**Subject: Application for Validation of the Canadian Nuclear Safety
 Commission Package Design Approval Certificate CDN/2078/B(U)-96
 (Rev.0) for the F-458/F-245, F-458/F-247, F-458/F-251, F-458/F-251
 MK2, F-458/F-318 and F-458/F-448 Transport Packages**

This letter and the attachments form the response to the US Nuclear Regulatory Commission, Request for Additional Information enclosed in your email of July 20, 2005. The additional information is for Docket No. 71-3076, MDS Nordion model nos. F-458/F-245, F-458/F-247, F-458/F-251, F-458/F-251 MK2, F-458/F-318 and F-458/F-448, Canadian Package Design Certificate No. CDN/2078/B(U)-96.

**Reprinted Page J-5
IS/TR 1783 F458/F251 (2)**

FIGURE A3-6 SEAL LIFE AT TEMPERATURE

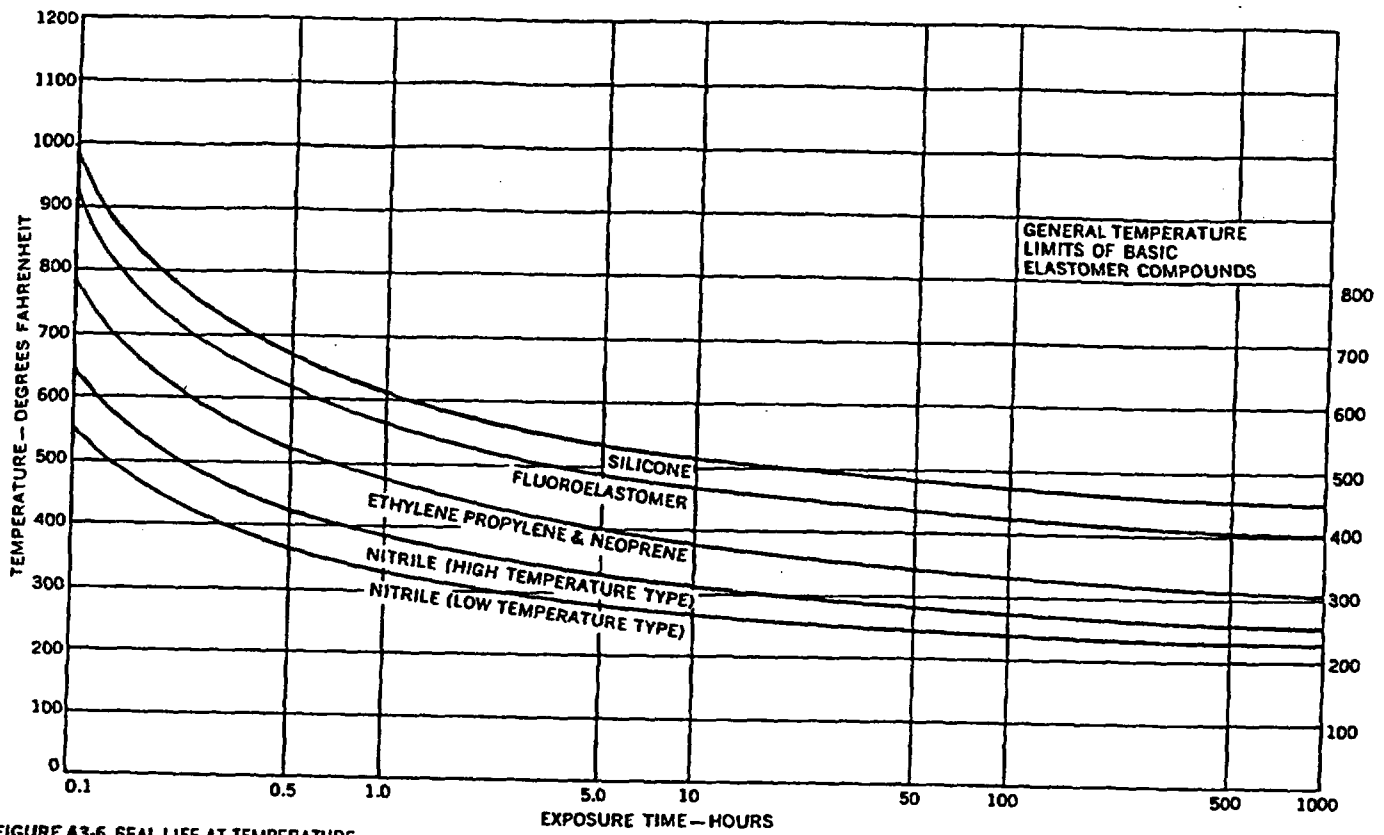
7. Justify the temperature limit of the O-ring in the leakproof insert as being 149 °C as stated in Appendix 11, Section 4.2.3. Considering the uncertainties in the calculation method, justify the conclusion that the O-ring is suitable for the Hypothetical Accident Condition fire.

The calculated maximum temperature of the O-ring is 133°C (refer to Section 7.2 of Addendum 11I). Appendix 2.1 drawings show the O-ring as neoprene. The 1992 edition of the Parker O-ring Handbook, page A3-35, shows the upper normal temperature range of a neoprene O-ring as 121 °C, with a short term temperature limit of 135 °C.

The temperature limit of 149°C for the O-ring in the leakproof insert is derived from Figure A3-6 in Appendix C. The O-ring seal is specified as a "Parker [REDACTED] or equivalent" [REDACTED] O-ring. Per the manufacturer's product handbook, the service temperature is -43°C to +150°C (-45°F to +300°F) per Table A3-13. From Figure A3-6, at 1000 hours, [REDACTED] has a temperature limit of 300°F that corresponds to the service temperature from Table A3-13 for Parker compound [REDACTED]. The comment on "Time" in the manufacturer's product handbook, page A3-37 is: "The curves show the safe, cumulative time at a given temperature for specific elastomers used as static seals. For dynamic seal applications, temperatures as much as 25 °F (14 °C) below those indicated may be more realistic."

The manufacturer also notes that actual temperature limits will vary based on the application. Figure A3-6 of the Parker handbook, Appendix A, shows that the general seal life at temperature for neoprene is approximately 1 hour at 240°C. Transient temperature excursions outside the normal service temperature range may be sustained by the neoprene. This is applicable to the accident conditions of transport (ACOT), since the elevated temperatures are transient.
